Summerlin Village 24- Parcel COS-3 Wash

CITY OF LAS VEGAS INTER-OFFICE MEMORANDUM		DATE: April 6, 2017
TO: Land Development Services Department of Building & Safety		FROM: Albert Sung, P.E. Flood Control Project Engineer Department of Public Works
SUBJECT:	Drainage Study for:	
	Summerlin Village 24 – Parcel COS-3 Wash	
Cross Streets:	Open Space between Parcel H and Parcel I	COPIES TO:
File Number:	F:\Depot\DSMemos\DS4869A.doc	GCW Engineers & Surveyors
Parcel Number:	137-33-810-004	Howard Hughes Company, LLC
Zoning Action:	FMP-62680	Bart Anderson, P.E., DevCo
FEMA Flood Zone	YES	NO X
Proposed Storm Drain	YES	NO X

The Drainage Study for the subject project has been reviewed and:

DRAWING
FIG-6
OF SHTS

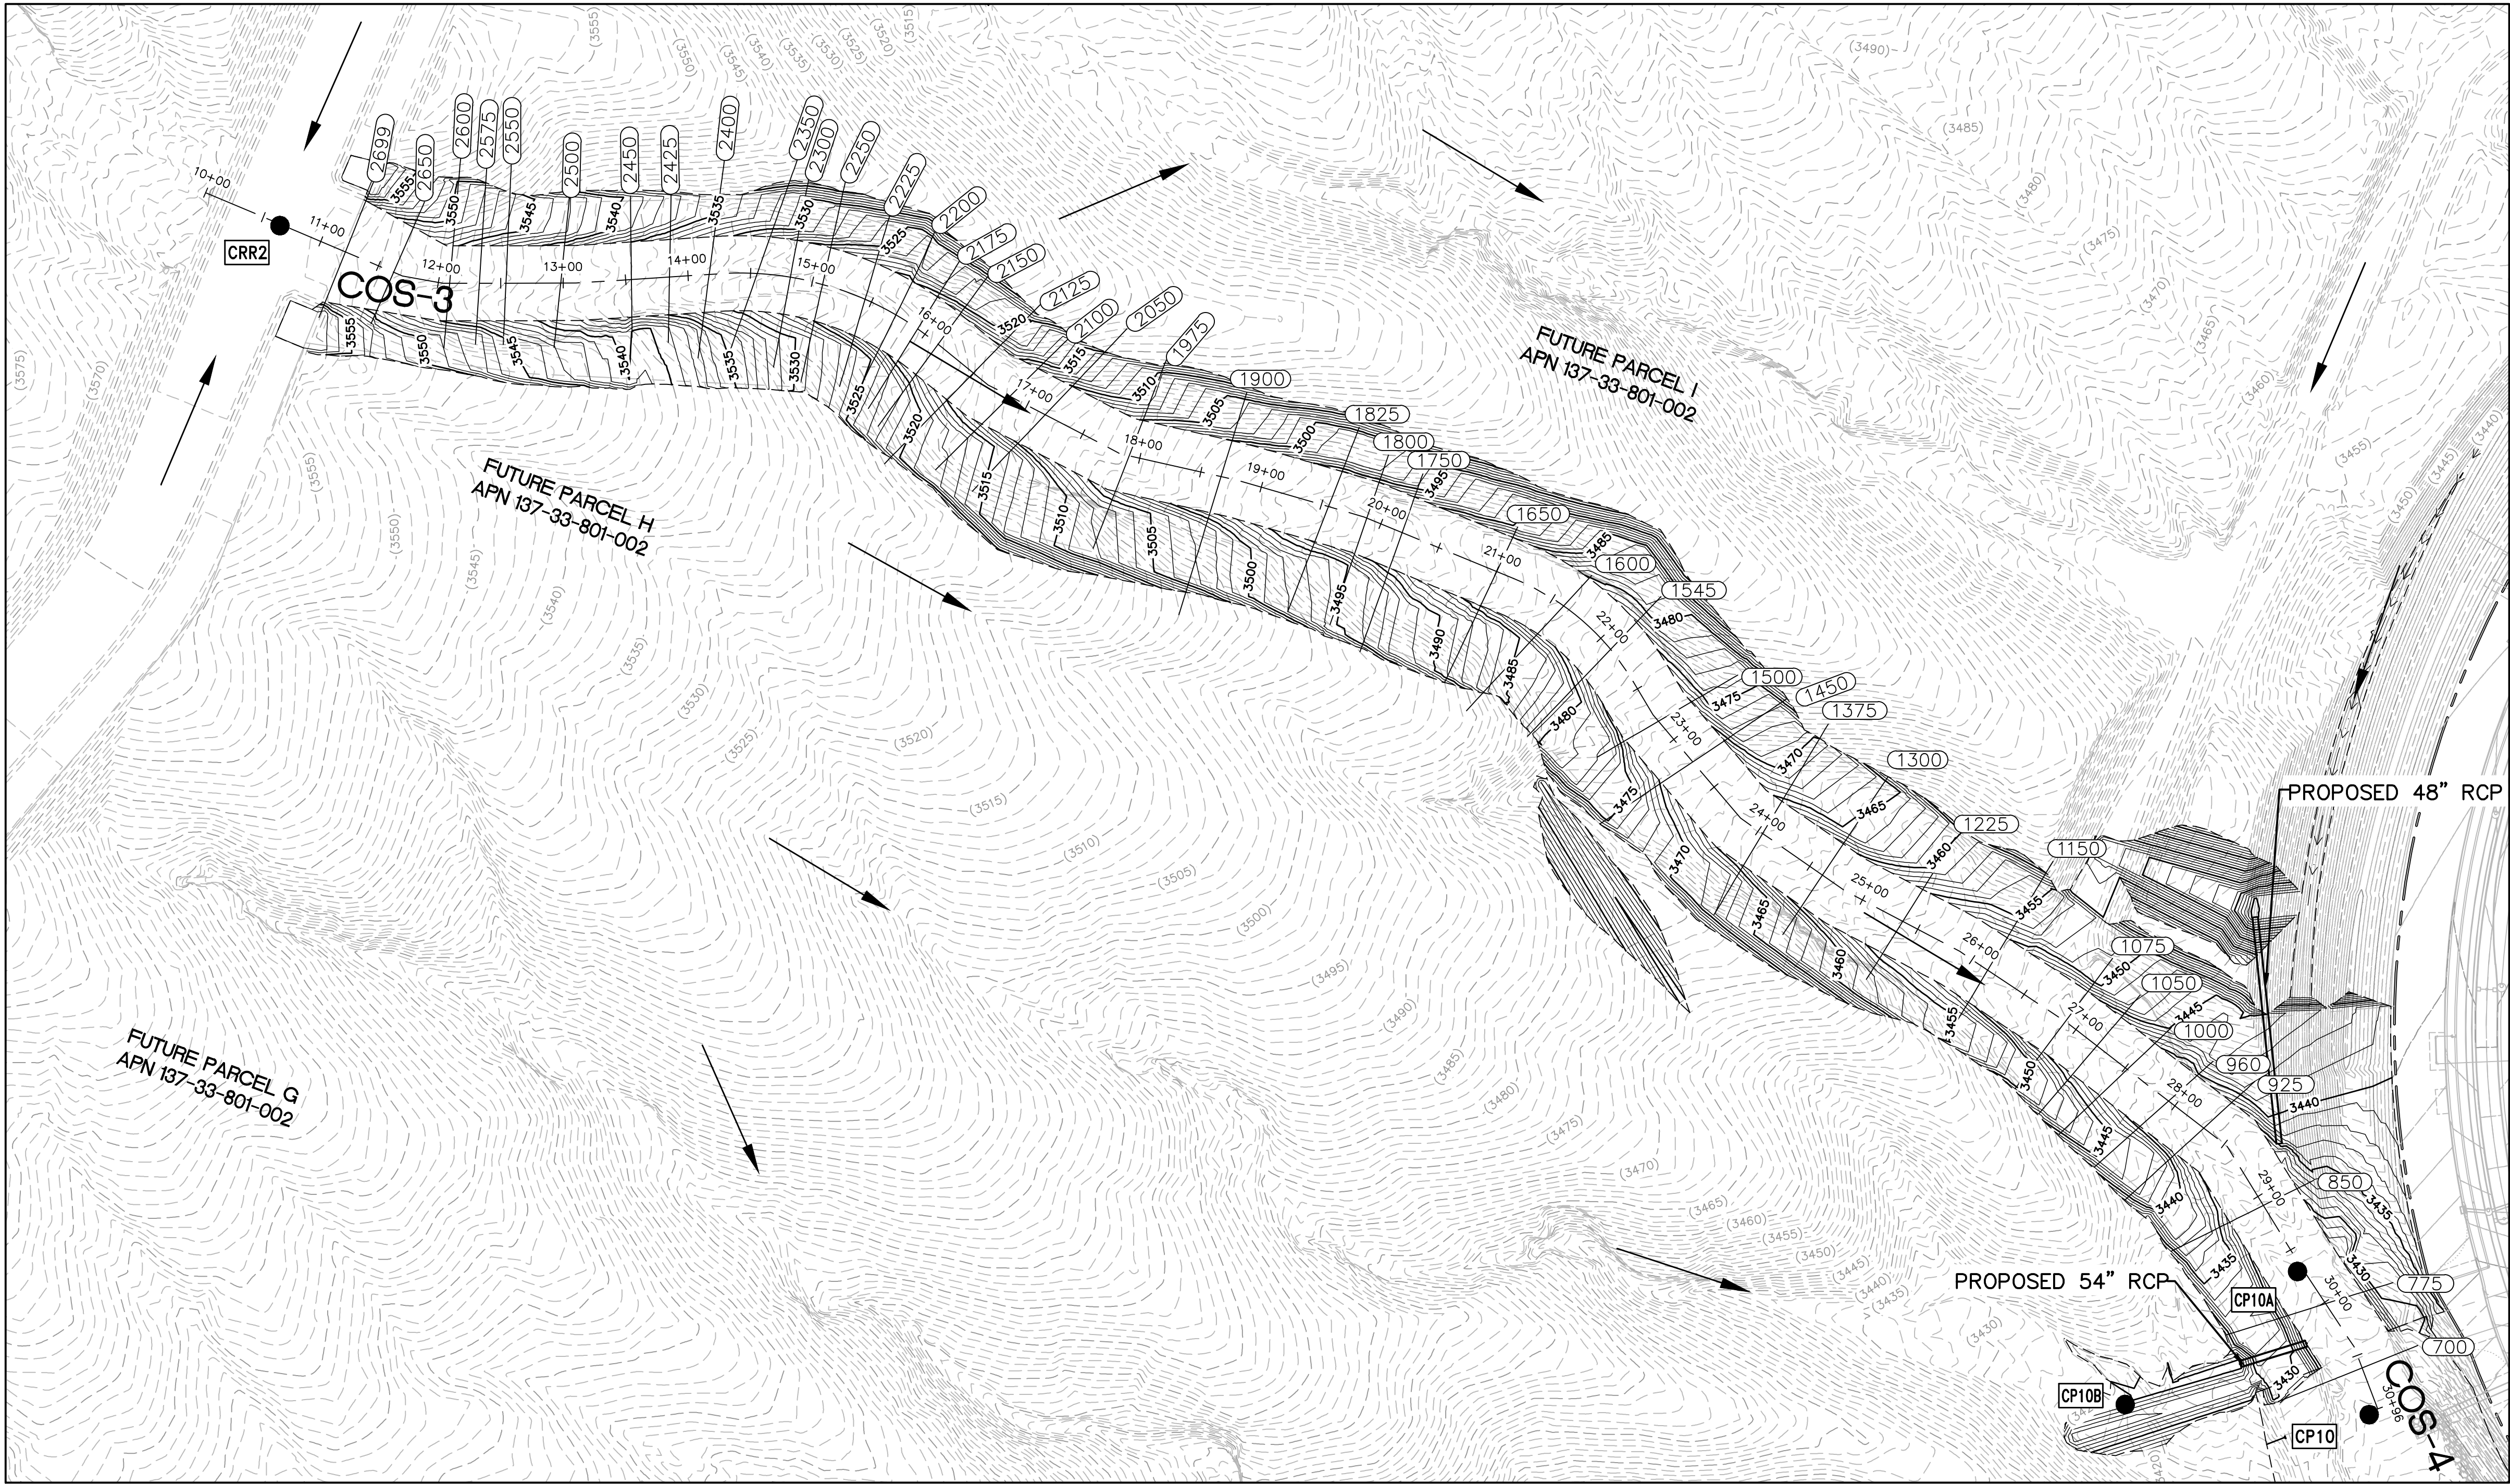
- The subject "COS-3" wash is a common lot and public drainage easement to be privately maintained by the developer and future *Homeowners Association*. Record as such in the final map.
- In **Figure 6 (HEC-RAS Cross Section Exhibit)** of the subject project, **River Station 550**, as the interface between COS-3 and the downstream COS-4 shows non-matching flow parameters as compared to Figure 7R of the COS-4 Study. River Station 550 shows velocity of 13.61 ft/s and Froude Number 2.56 in the subject project versus velocity of 15.31 ft/s and Froude Number of 3.03 in the COS-4 Study. Please explain the discrepancy in the next submittal.
- Provide a 12'-wide maintenance access road throughout the whole Parcel COS-3 for maintenance crew of the developer and the future Homeowners Association.
